MONITORING YEAR 4 ANNUAL REPORT

CANDY CREEK MITIGATION SITE

RE: **Draft Monitoring Year 4 Report Comments
Candy Creek Mitigation Site (DMS #96315)**
Cape Fear River Basin 03030002, Guilford County
Contract No. 005794

Figure 2 Project Components/Assets Map
 Candy Creek Mitigation Site
 DMS Project No. 96315
 Monitoring Year 4 - 2020
 Guilford County, NC

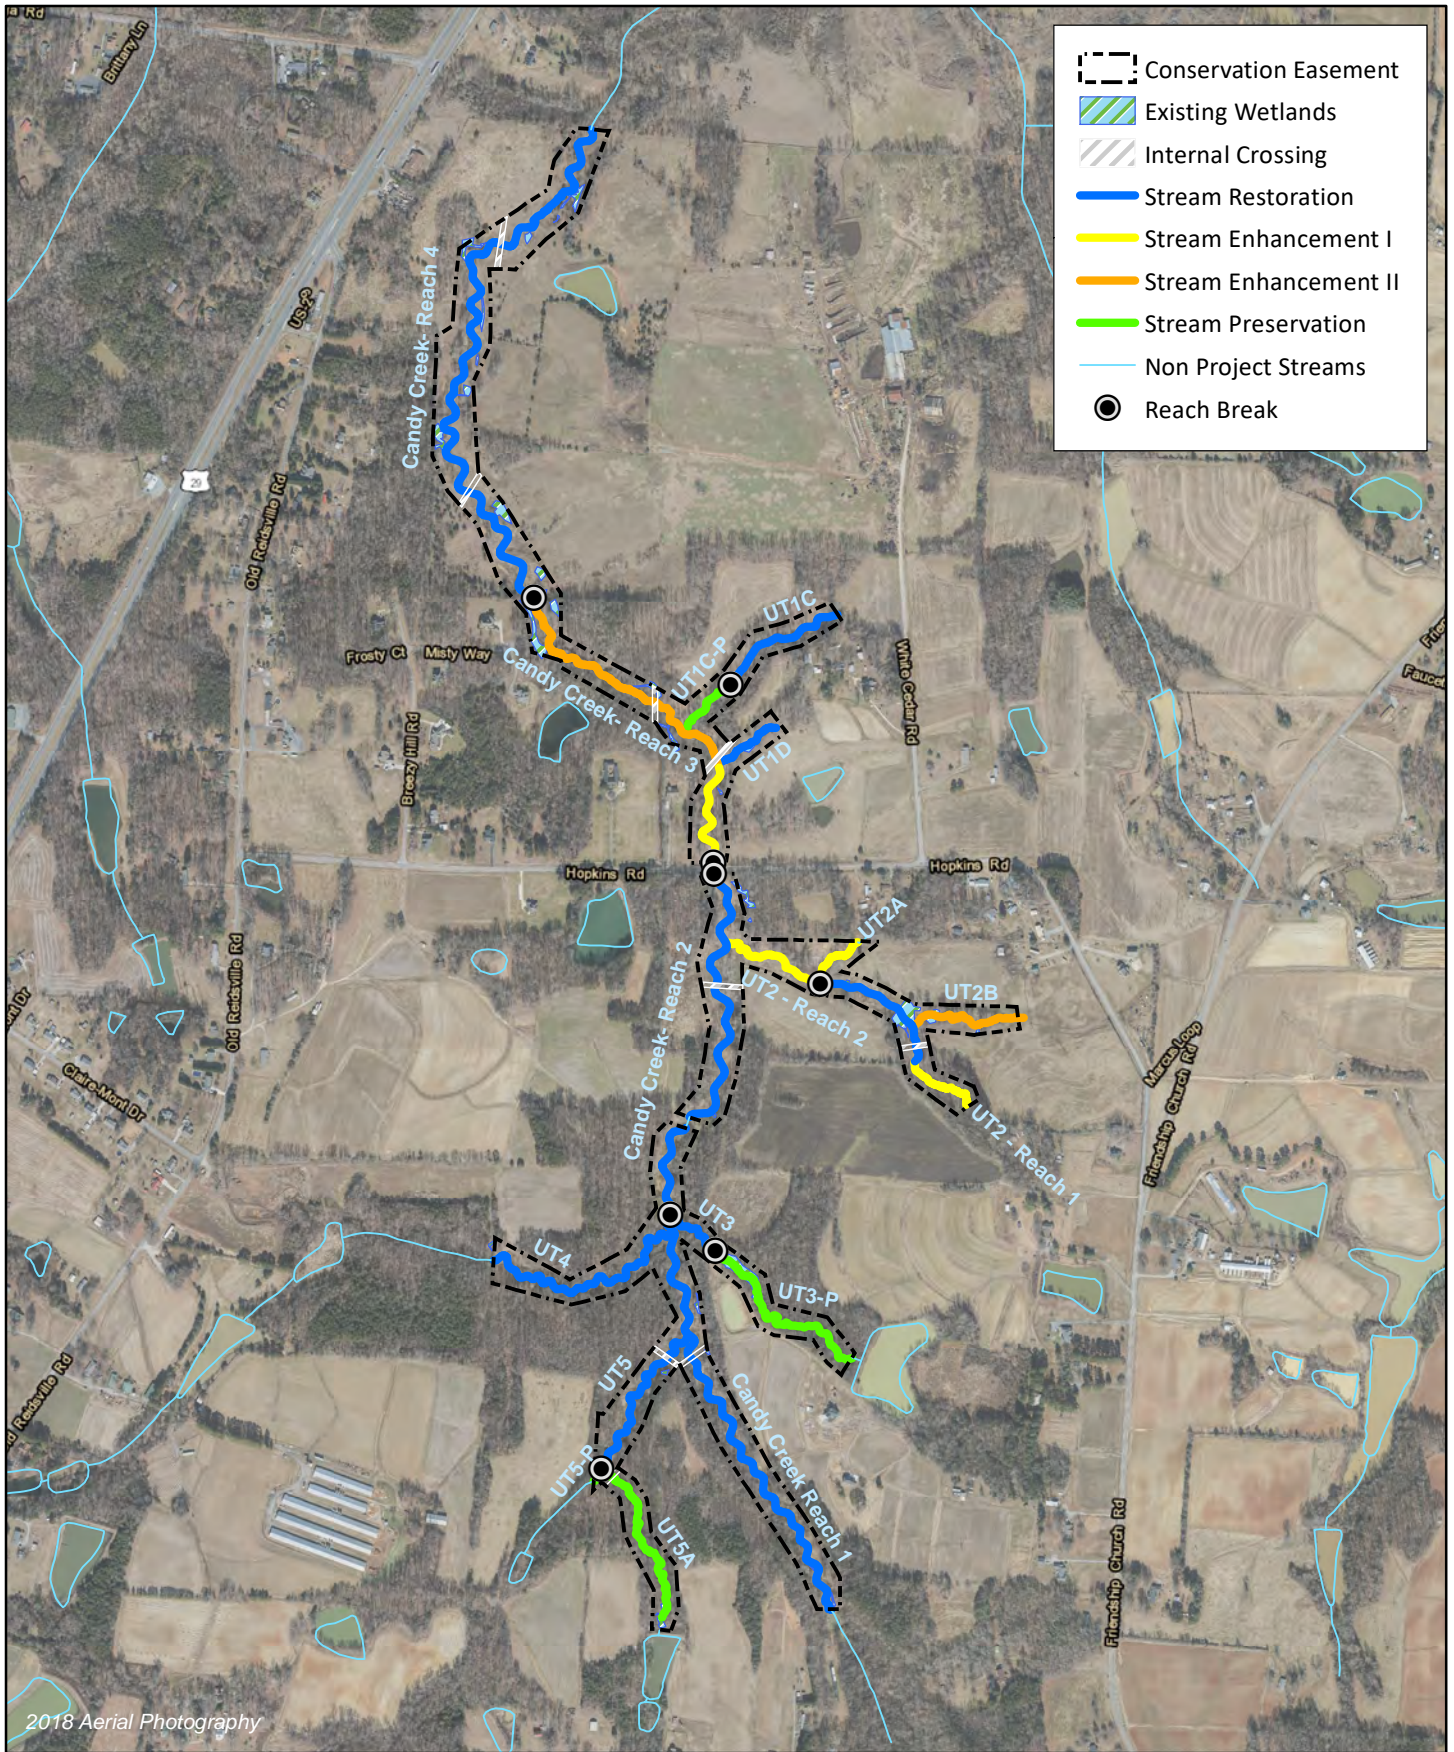
- a. **The feature for UT2A in the DMS geodatabase has a length of 376 ft, but the Restoration Footage/Acreage column of the asset table reports a length of 353 ft. Please resubmit a set of stream features that accurately characterize the length of UT2A.**

Wildlands' response: The Enhancement I portion of UT2A in the GIS dataset was corrected to the As-Built survey length of 353 ft. The figures 2, 3.0, and 3.4 now reflect this correction.

Figure 3.1 Integrated Current Condition Plan View
 Candy Creek Mitigation Site
 DMS Project No. 96315
 Monitoring Year 4 - 2020
 Guilford County, NC

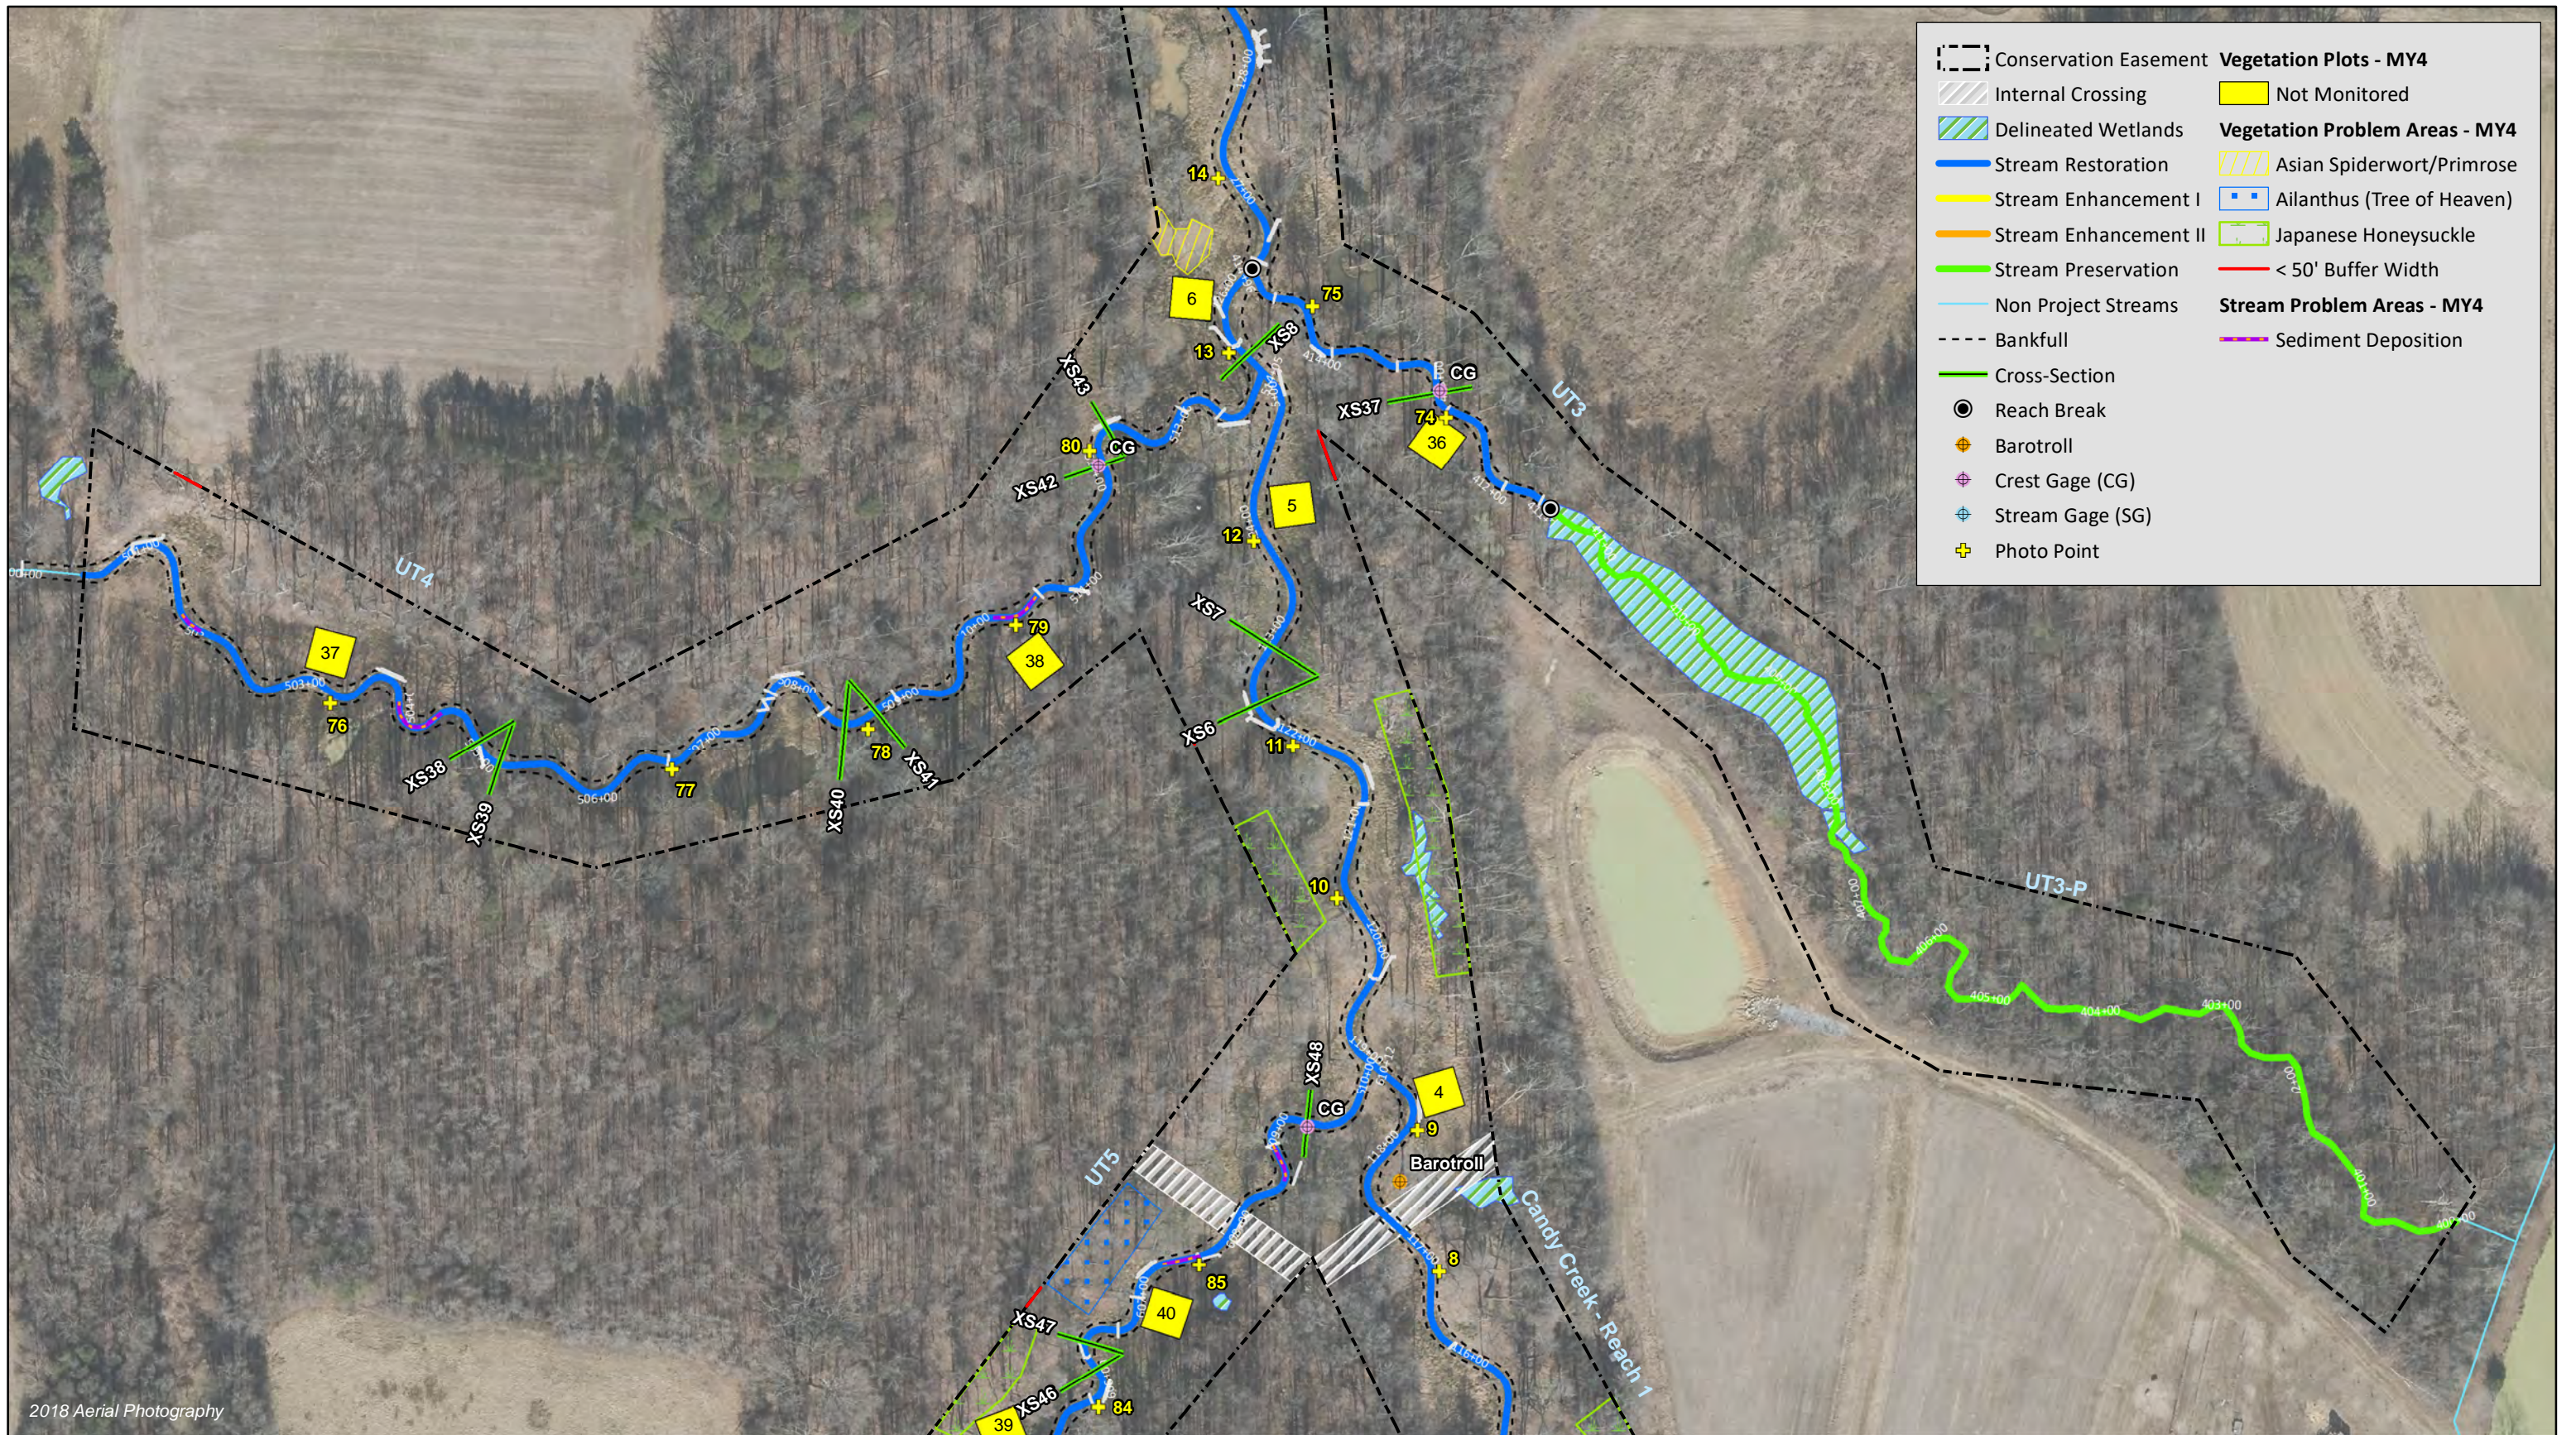
DMS' comment: Section 1.2.5.2 Vegetative Assessment: Add a reference to the CCPV figures showing the mowing encroachments discussed at the end of this section.

DMS' comment: Appendix 1, Table 2 - Project Activity and Reporting History: Include the easement signage installed during MY4 as a project activity in Table 2 and call out the locations on the CCPV figures.

Wildlands' response: The text has been updated to reference the specific CCPV Figures depicting the three areas of encroachment (Figures 3.1 and 3.5 of Appendix 2).

Wildlands' response: As mentioned in Section 1.2.6: Adaptive Management Plan, additional signage was installed during a prior monitoring year (clarified to MY3), and additional signage may also be installed in the future; however, no signage was added during MY4. The Appendix 1 Table 2 was updated to reflect that an additional easement marker was installed in September 2019, and the location of the new sign was added to the CCPV Figure 3.1.
